STATE OF TENNESSEE
DEPARTMENT OF ENVIRONMENT AND CONSERVATION

RE: Addendum 4 (Exposure Unit Z2-11) to the Fiscal Year 2009 Phased Construction Completion Report for Zone 2 Exposure Units 11, 12, 17, 18, 29, and 38 at East Tennessee Technology Park, Oak Ridge, Tennessee (DOE/OR/01-2415&D2/A4)

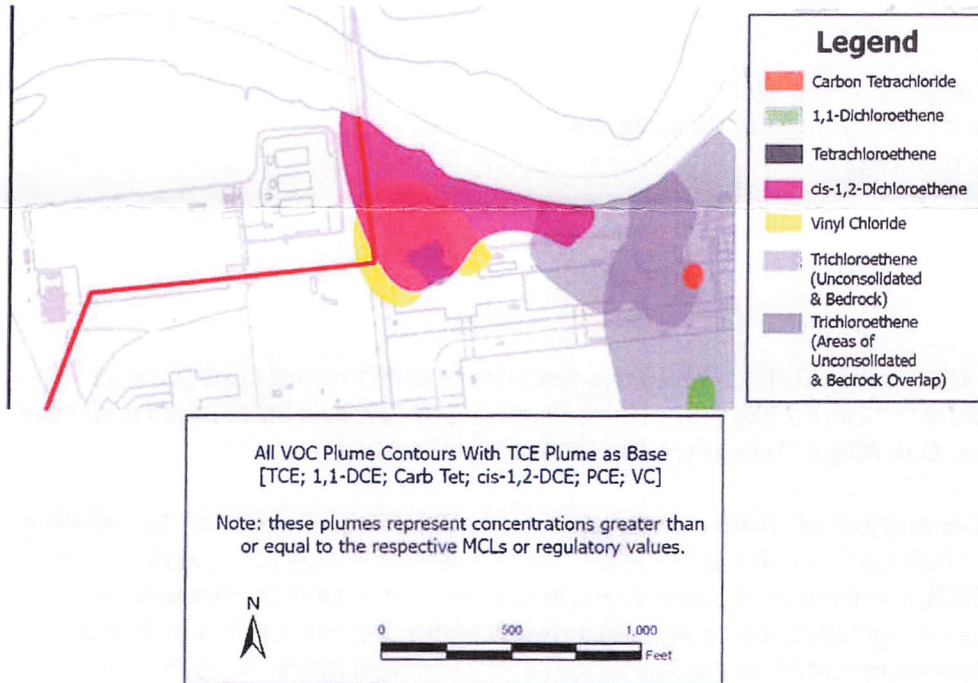
As part of the pre-RIWP sampling effort by the ETP groundwater team, many wells throughout the main plant area were re-sampled and re-evaluated for synoptic groundwater levels to produce more accurate groundwater flow maps. Results from this effort were used to redraw plume maps. While it is understood that these plume maps are approximated, it is important to note that the nature and extent of these plumes have not been defined, and uncertainty exists with respect to understanding the extent of groundwater contamination within EU Z2-11. The most recent plume map has identified volatile organic compound (VOC) contamination (e.g., trichloroethene, cis-1,2-dichloroethene, vinyl chloride, and carbon tetrachloride) in groundwater greater than maximum contaminant levels (MCLs) near the eastern boundary of EU Z2-11. Specifically, wells Z2-EU13B-1068P, Z2-EU13B-1066P, and Z2-EU13B-1064P, which are

within 100 feet of the EU Z2-11 boundary, yielded VOC results well above MCLs. Updated plume maps (see below) indicate plume expansion into EU Z2-11 on the eastern boundary. Please re-evaluate the vapor intrusion (VI) pathway by comparing the default and site-specific VI screening levels to the recent VOC results in EU Z2-13. Please update Section 6 as appropriate based on results of VI pathway re-evaluation.
